**QUESTIONS-ANSWERS-CLARIFICATIONS**  
**COMMUNITY CENTER SECURITY CAMERA PROJECT**  
**PROJECT NO. CR23005**

**Questions & Answers No. 2 – April 28, 2023**

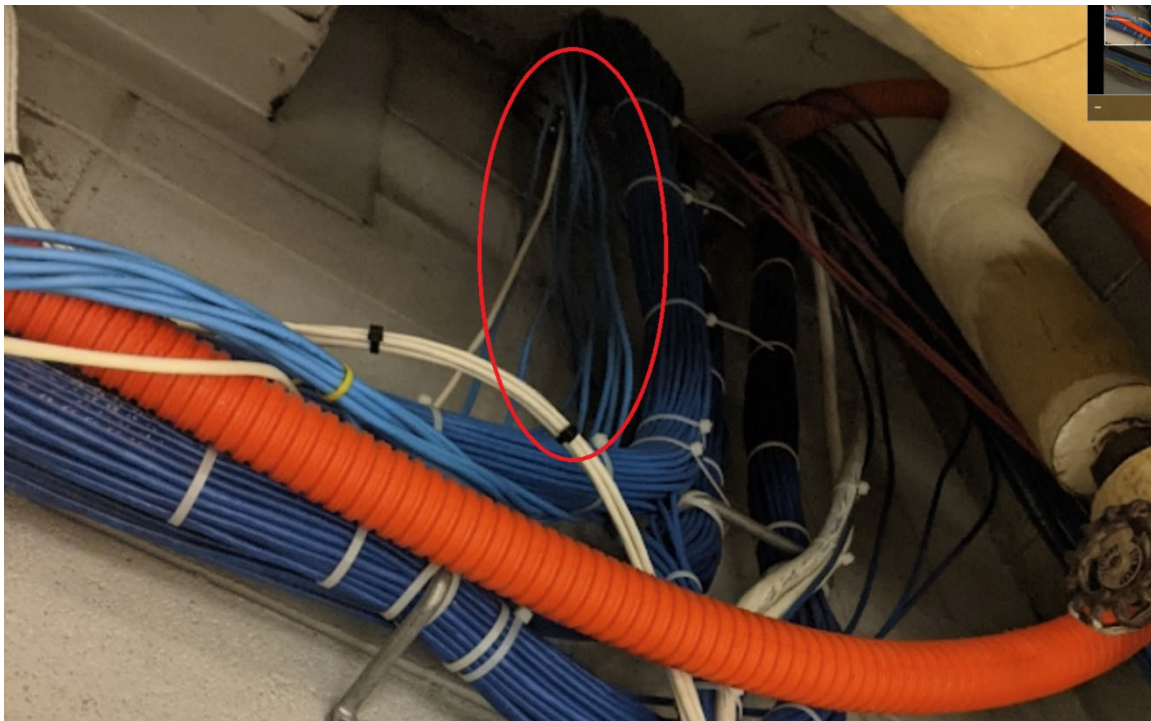
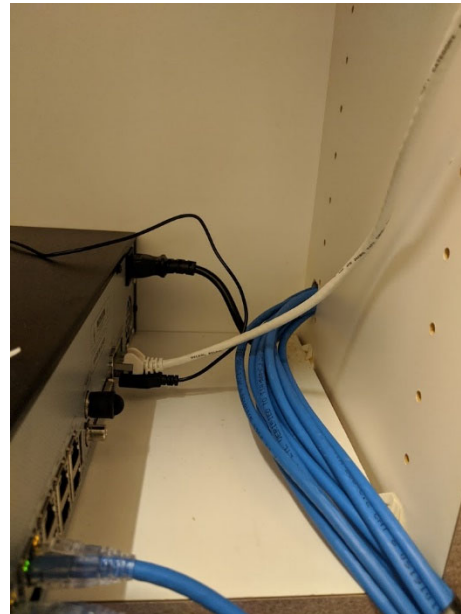
These systems are most likely to have a browser-based front end/portal. The systems must be able to keep up with browser-based security requirements that will continuously need to be updated/upgraded. Trying to avoid systems that are specific browser dependent or the “use this browser because it’s less secure” scenario.

Network cable color and network keystone (jacks) are not necessarily the same color.

Cable Colors– The following is the color standard for all horizontal cable on campus (as of 03/18/2022)

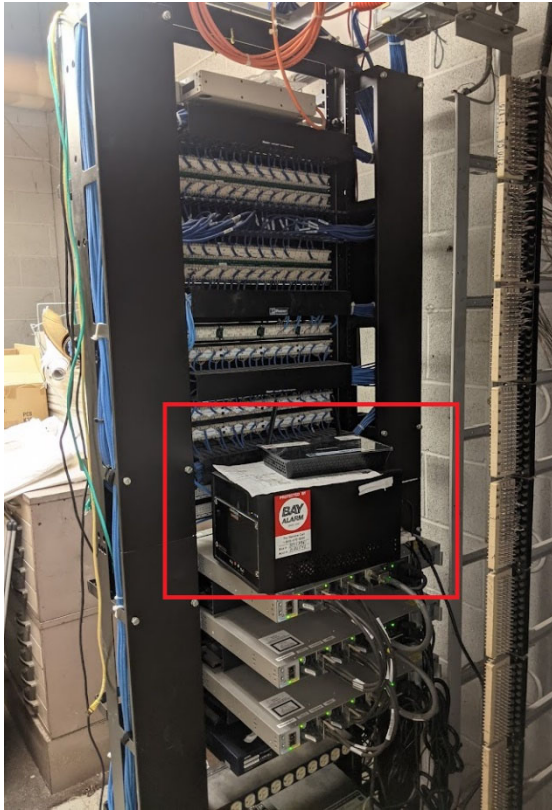
Our primary concern is the keystone (jack) color. Varying the cable color itself helps us trace lines later down the road and sometimes allows us to distinguish between the type (Cat5/5e/6/6a) of cable used for City Network connections at each site.

Purpose	Data / VoIP	Audio / Visual	Security / Cameras	Wireless	Building Automated Systems	Lighting Controls	PA System
Cable Type	Cat 6	Cat 6	Cat6a	Cat 6a	Cat 6	Cat 6	Cat 6
Cable Color	White	White	Green	Green	Gray	Yellow	Gray
Keystone (Jack)	Left – yellow Right - blue	Purple	Red	White	Orange	TBD	Gray
